4294A-05D

S E R V I C E N O T E

Agilent 4294A Precision Impedance Analyzer

Part Number Changes for LCD and LCD Assemblies with backlight lamp change recommendation

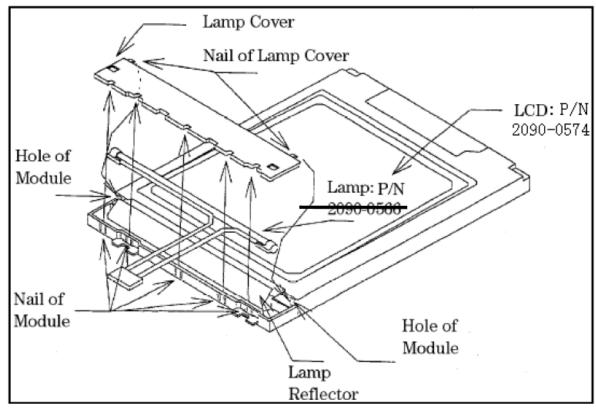
Replace whole OLD LCD units.

Part Number	Qty	Description
5185-3731 * 1	1	A52 LCD 8.5 inch
0950-2924	1	A54 Inverter
(Replaced by E4970-65001)		
04294-04001	1	Cover
E4970-25002	1	Insulator
04294-61620	1	Cable
04294-00603	1	Case Shield
04294-60001	1	Chassis

^{*1:} Refer to the above "Situation" part, and change only a lamp (2090-0566) if it is burnt.

2090-0556 was replaced by 5188-1640

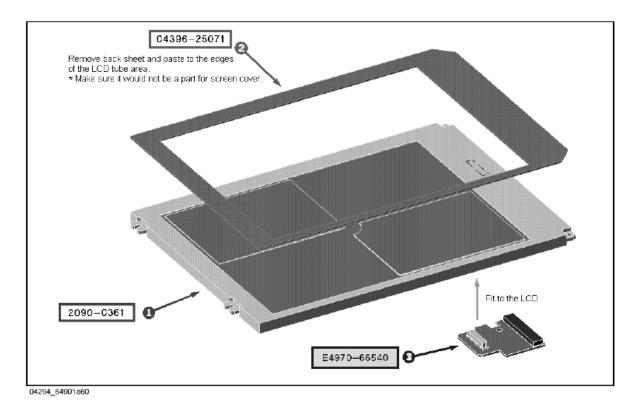
When replacing the backlight lamp in the old LCD, remove the lamp install new one as illustrated in the following figure.

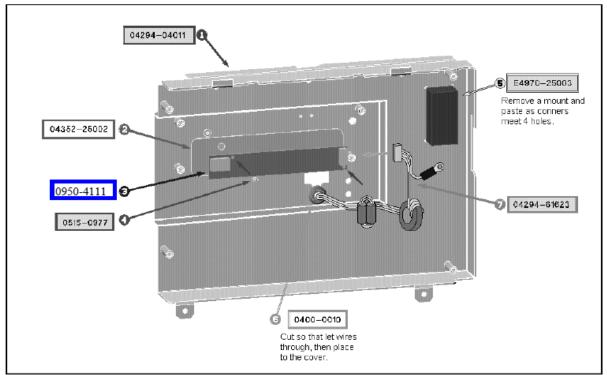
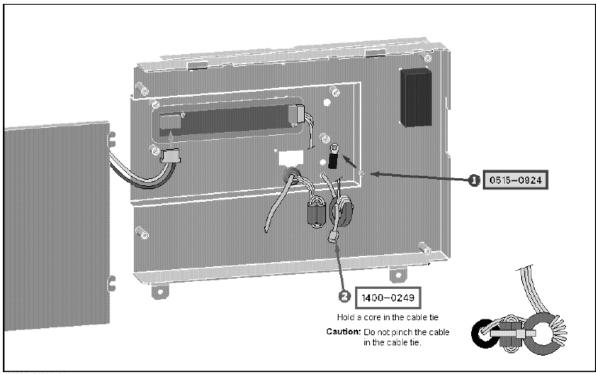
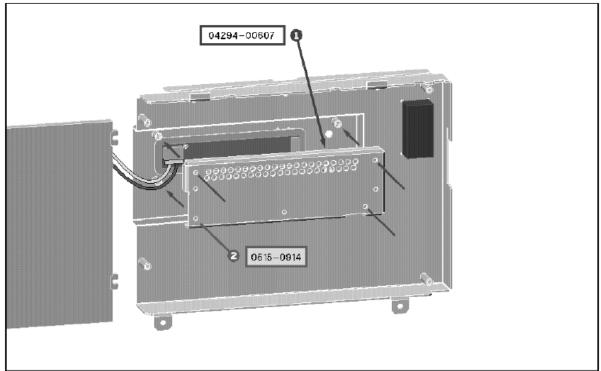
The procedure for the new LCD assemblies are as described below.
